**Car Stereo
Service Bulletin**

Model: CDX-A30RF

No. 168

Subject: Spikes On ACC Line Cause
Misoperation

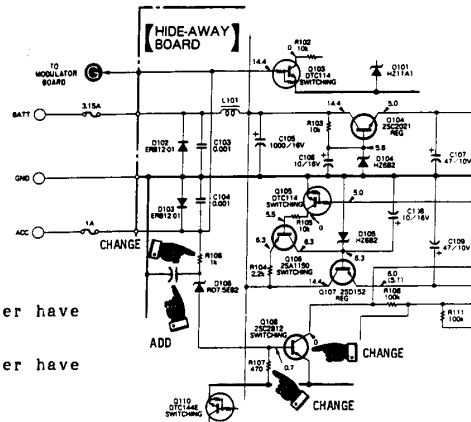
Unit mutes when lights, wipers, or fan are turned on.

Cause: The ACC line varies due to spikes caused by switching.

Solution: Change the following parts:

| | Description | | | |
|--------|-------------|---------|----------|--------------|
| Change | Q108 | 2SC2812 | DTC144EK | 8-729-901-01 |
| | R106 | 1k Ohm | 2.2k Ohm | 1-216-057-00 |
| | R107 | 470 Ohm | 22k Ohm | 1-216-081-00 |
| Add | ---- | ----- | 10u/16V | 1-126-157-11 |
